GROUP FUE	MODEL 2019-2020MY Forte (BDm)
	NUMBER 047	DATE August 2020
TECHNICAL SERVICE BULLETIN		
SUBJECT: NU 2.0L MPI MIL ON DTC P010100 AND/OR P010600 AND/OR P006800 LOGIC IMPROVEMENT

This bulletin provides the procedure to improve the logic of the Engine Control Module (ECM) software and clean the Electronic Throttle Control (ETC) on some 2019-2020MY Forte (BDm) vehicles equipped with NU 2.0L MPI Atkinson engine, which may exhibit a MIL with DTC P0101, and/or P0106 and/or P0068. To correct this concern, apply the improved logic to the ENGINE system using the KDS ECU Upgrade function if any combination of the DTC(s) are set and clean the ETC as described in this bulletin. For confirmation that the latest reflash has been applied to a vehicle you are working on, verify the ROM ID using the table on pages 3-4 of this bulletin.

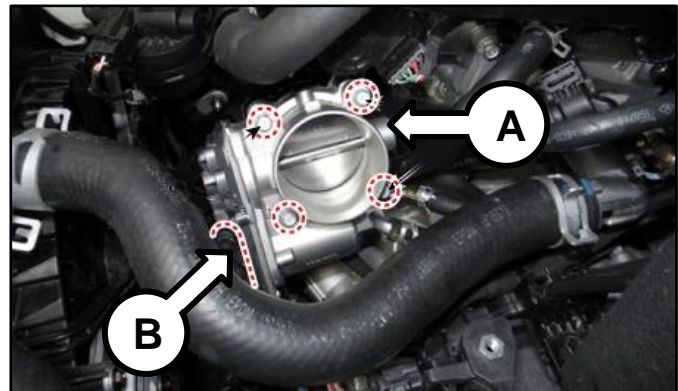
1. Remove the ETC (A) assembly by referring to the “Engine Control/Fuel System → Engine Control System → ETC (Electronic Throttle Control) System → Repair procedures” chapter in the applicable Shop Manual on KGIS.

Using a clamp tool, clamp the ETC coolant hose (B) to reduce coolant loss.

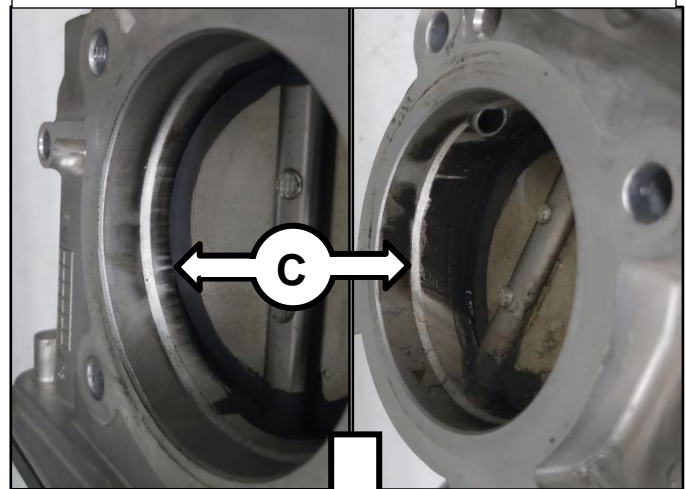
2. Using UM040 CH010 (or equivalent) cleaner, spray onto a lint free towel, then wipe the inside wall (C) of the ETC inlet to remove any carbon deposits.

The ETC throttle plate features a special coating (D) around the outside diameter of the plate. **DO NOT** use a wire brush and attempt to remove the coating.

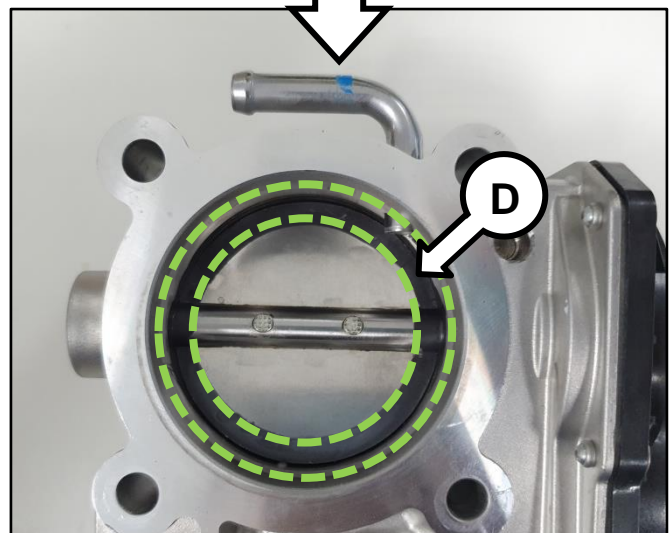
DO NOT wipe off the throttle plate coating (D), doing so (as shown below) may cause an idle performance issue.
